**ADDENDUM NO. 1**

**DATE:** April 10, 2018  
**FROM:** City of Grand Junction Purchasing Division  
**TO:** All Offerors  
**RE:** 2018 Sewer Line Replacement Project – Phase A

## HORIZON DRIVE SANITARY MANHOLE SCHEDULE

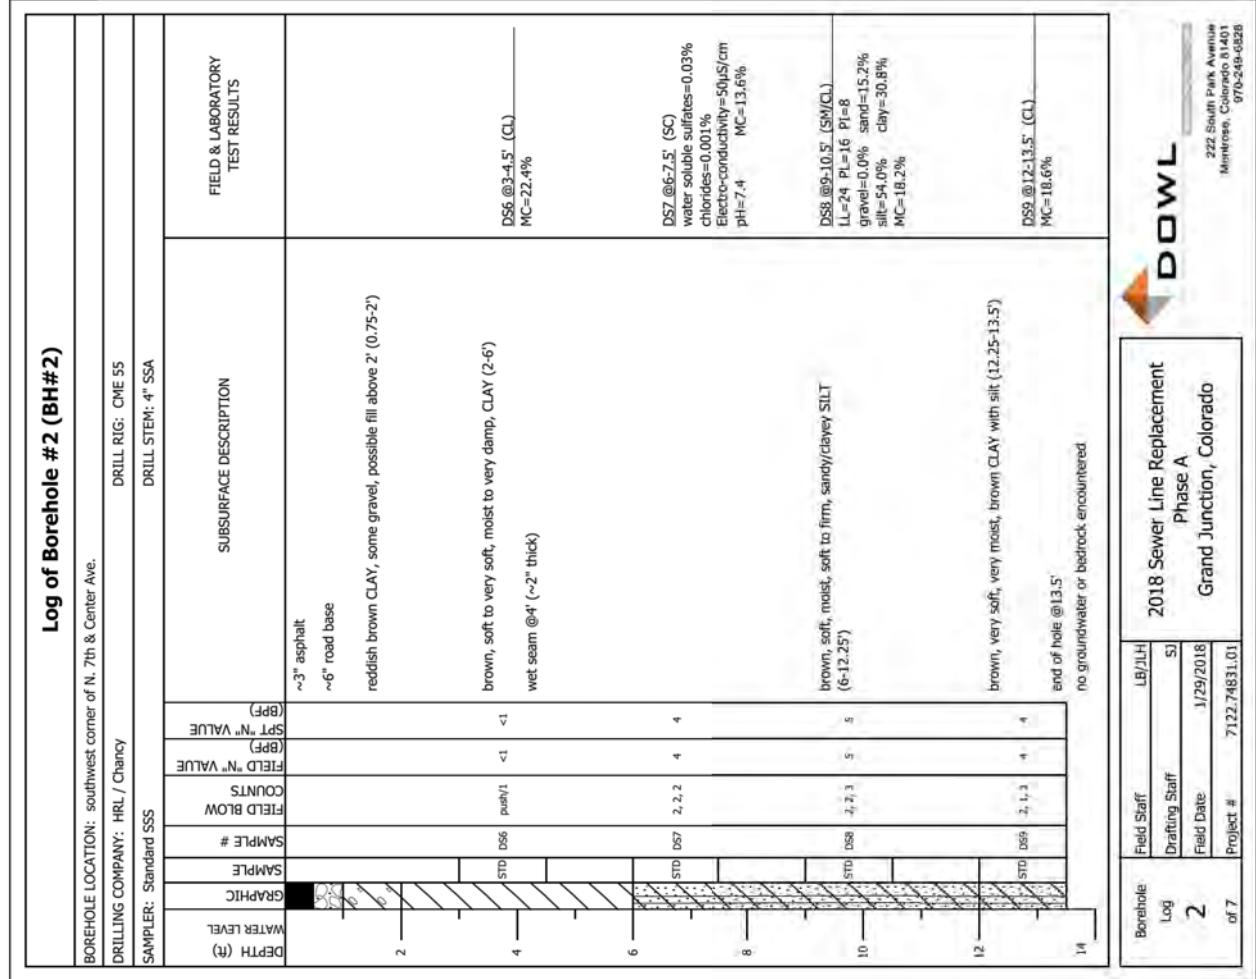
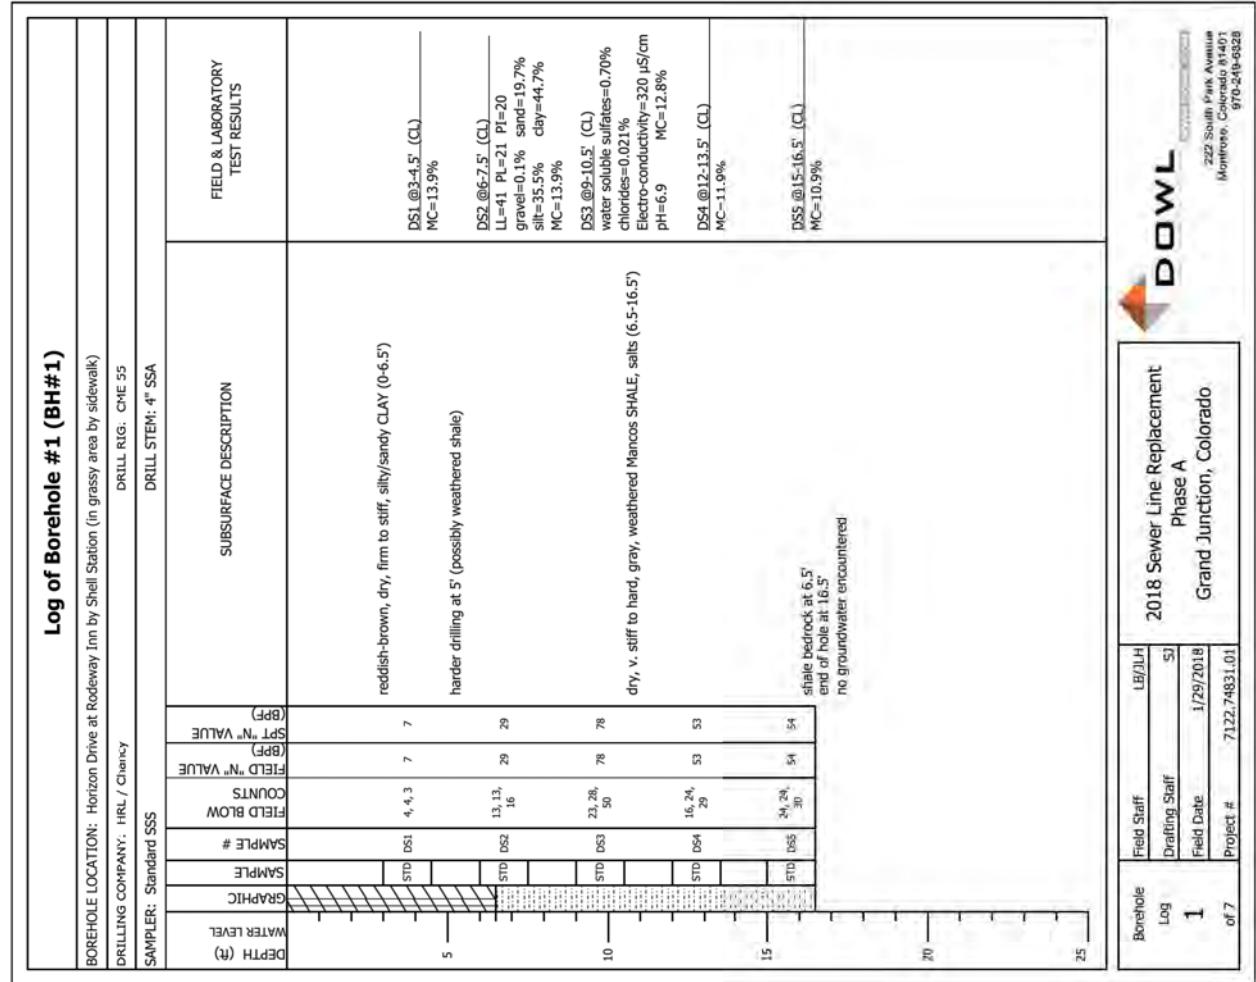
7. Question #5 – Sheet 18, Manhole G1-271-041 is shown for replacement. Is this necessary?

Answer – This manhole G1-271-041 on Horizon Drive is to remain in-place. The construction note calls out for the Contractor to connect the new PVC sewer pipe into this existing manhole.

### TYPICAL PIPE BURSTING SETUP

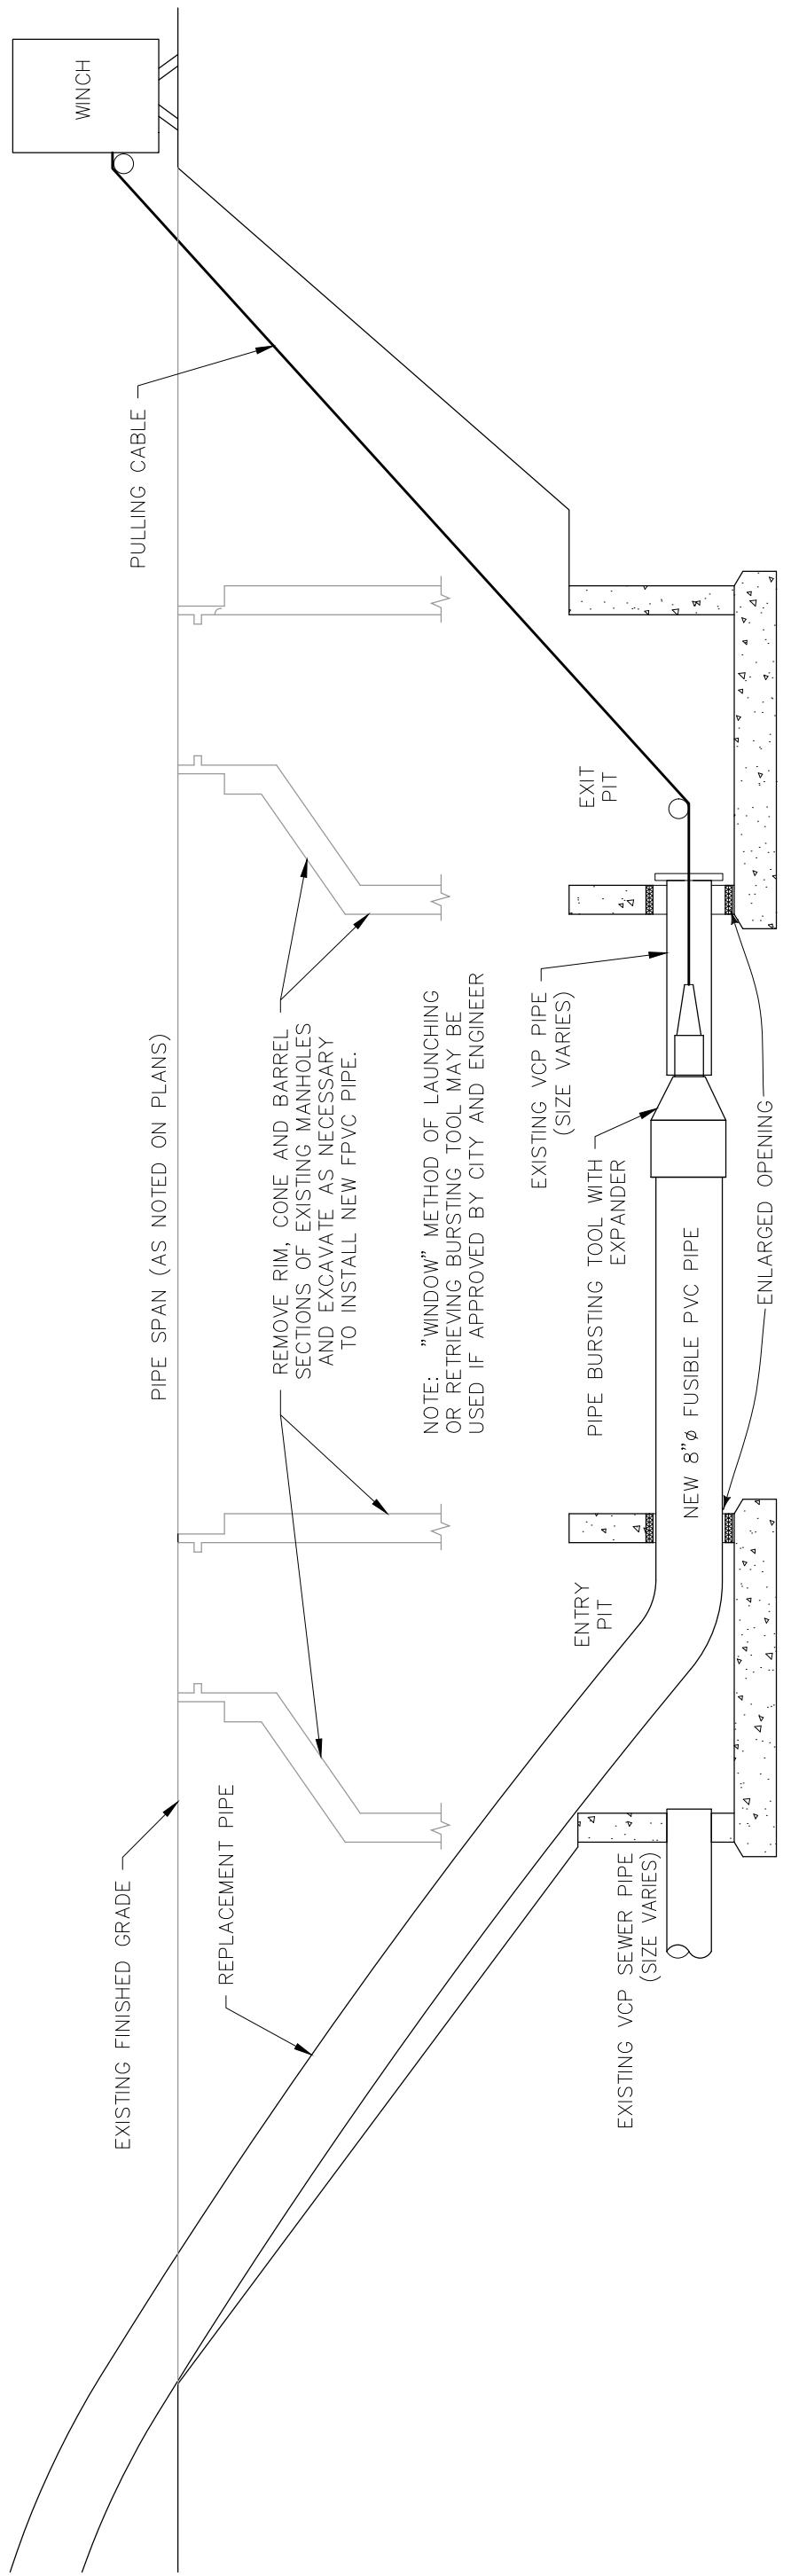
4. Question #2 – Will the City allow the use of fusible HDPE pipe for use with the pipe bursting segments?

Answer – No, the City will not allow the use of fusible HDPE pipe to be used with the pipe bursting operations. Per this Addendum #1, the City will allow either 8-inch Fusible PVC pipe or 8-inch Certa-Lok (CertainTeed) Restrained Joint PVC pipe for the pipe bursting segments.

Refer to the updated Special Provision section, within this Addendum #1, regarding alternative sewer pipe to be used with the pipe bursting operations.
